SPRINGS AT WATERVIEW - AMENDED STORM

GRINNELL DITCH NORTH - PLAN / PROFILE

GRINNELL DITCH SOUTH PROFILE

STORM B PROFILE

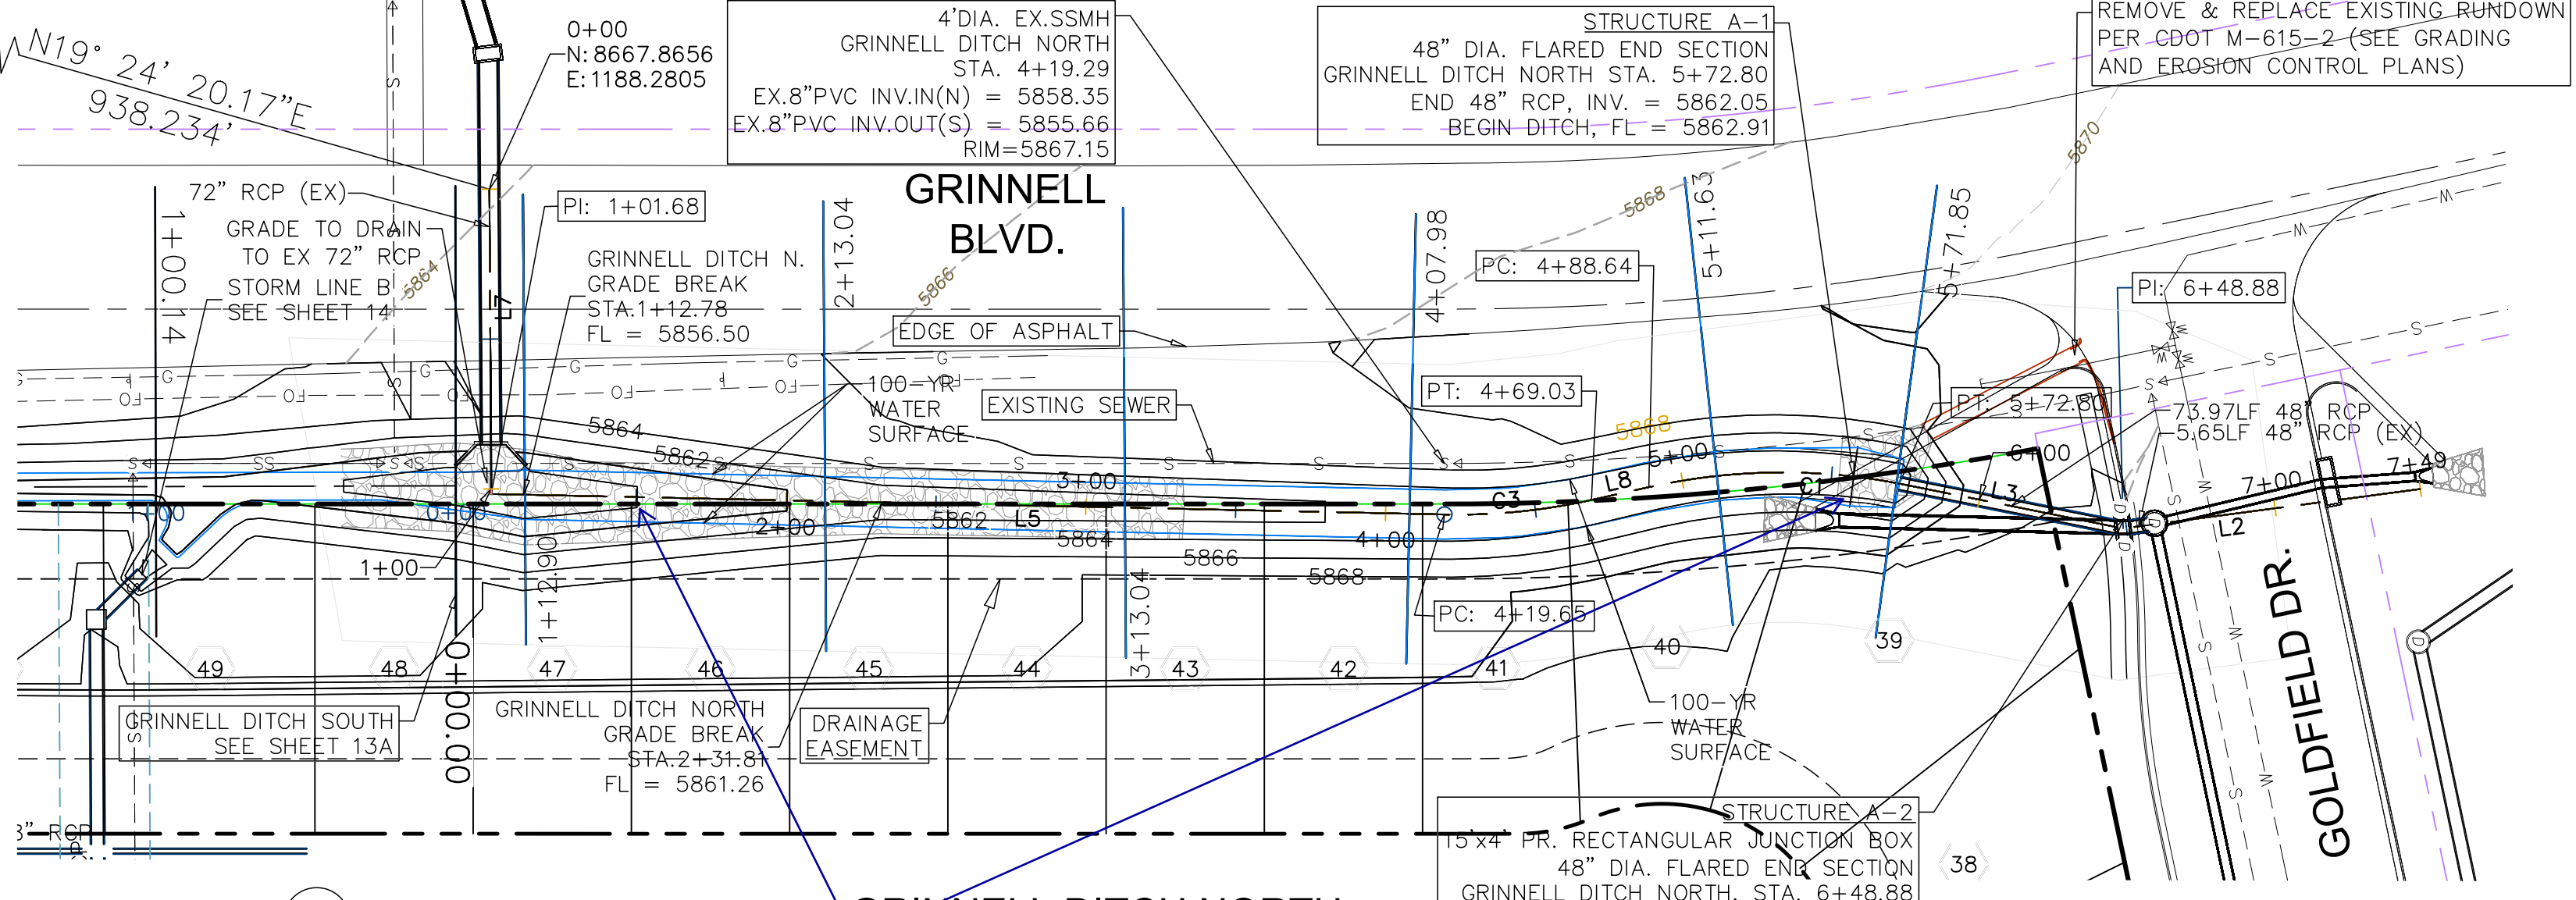
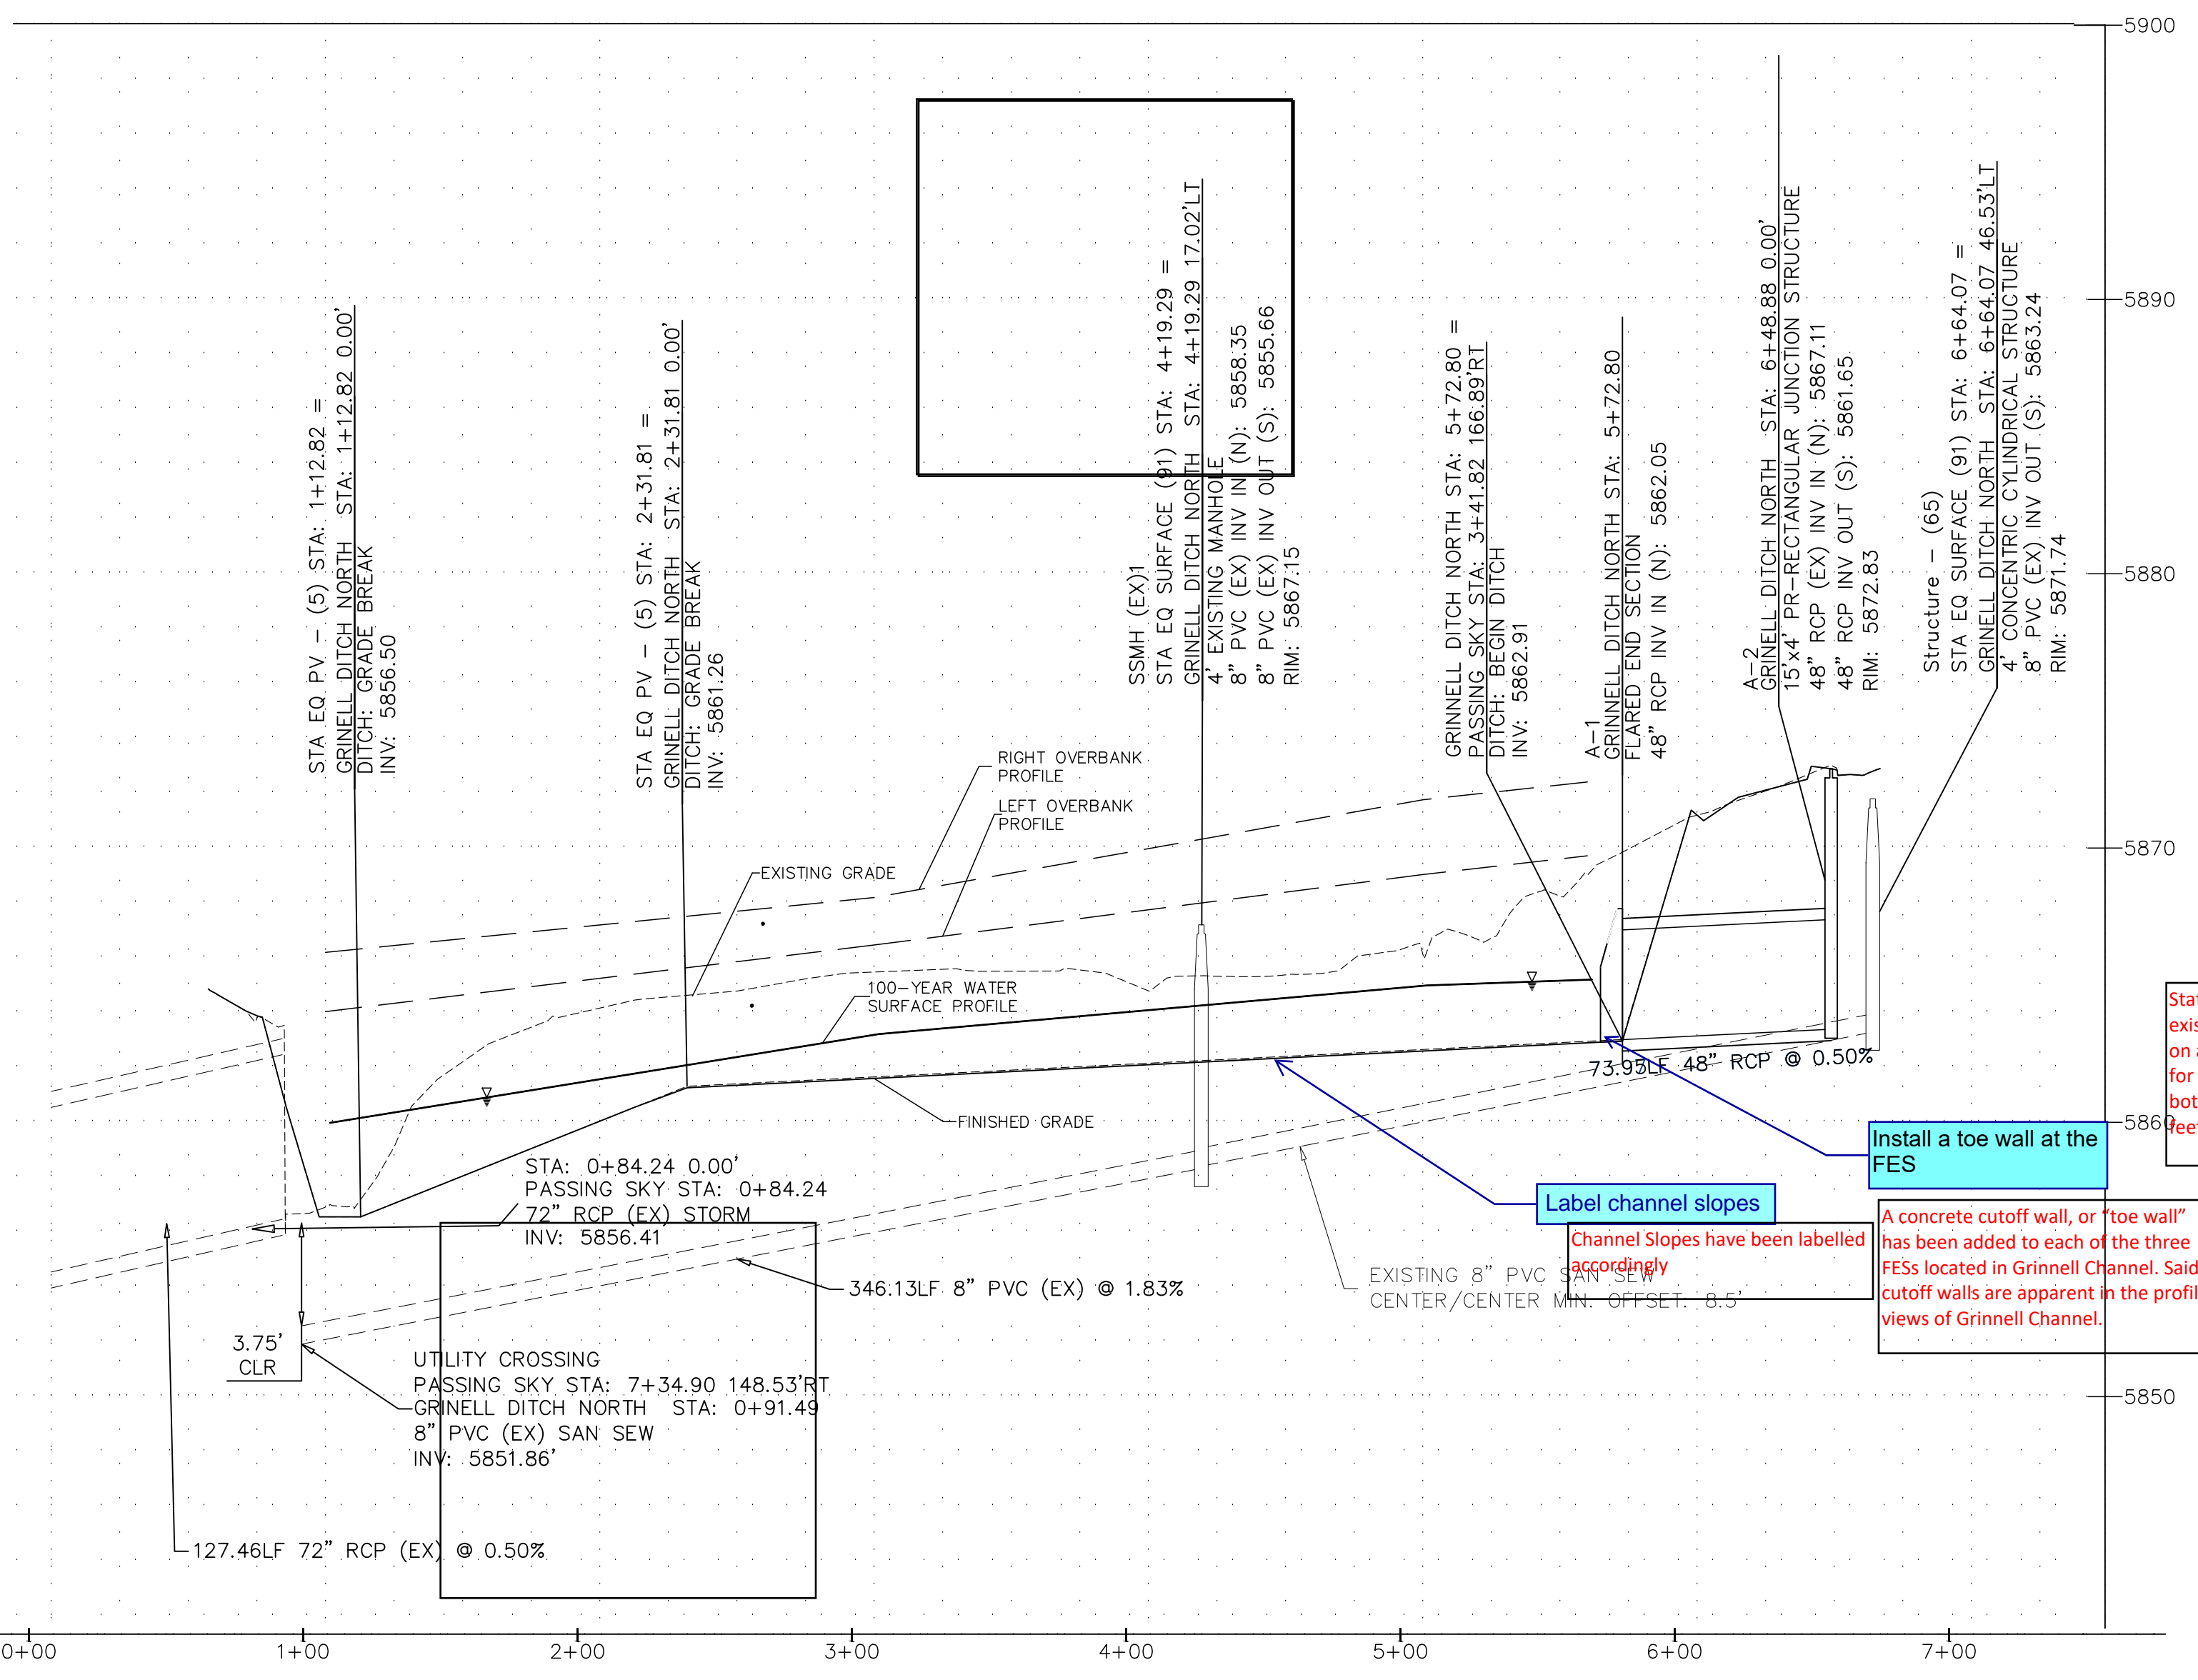
Provide riprap details. Identify the riprap type, length width, depth. Is there a lining between the riprap and subgrade?

Label channel slopes accordingly

Install a toe wall at the FES. A concrete cutoff wall, or 'toe wall' has been added to each of the three FESs located in Grinnell Channel. Said cutoff walls are apparent in the profile views of Grinnell Channel.

The property line is located in the middle of the channel. The

For all cross sections: - Label the station offsets of the toes. - Channel bottom width appears to vary - Label the existing and proposed grades.

Is this supposed to be the edge of asphalt. Plat only shows a property line.

Drainage easement on the plat was only 25 feet. It should be adjusted to include the entire channel side. Please refer to the discussion in the revised drainage letter.

RIPRAP details are included and provide the requested information.

The property line is, indeed, located in the middle of the channel.

Edge of Asphalt was erroneously labeled as ROW in many of the cross sections. The labels have been updated accordingly, to indicate edge of asphalt.
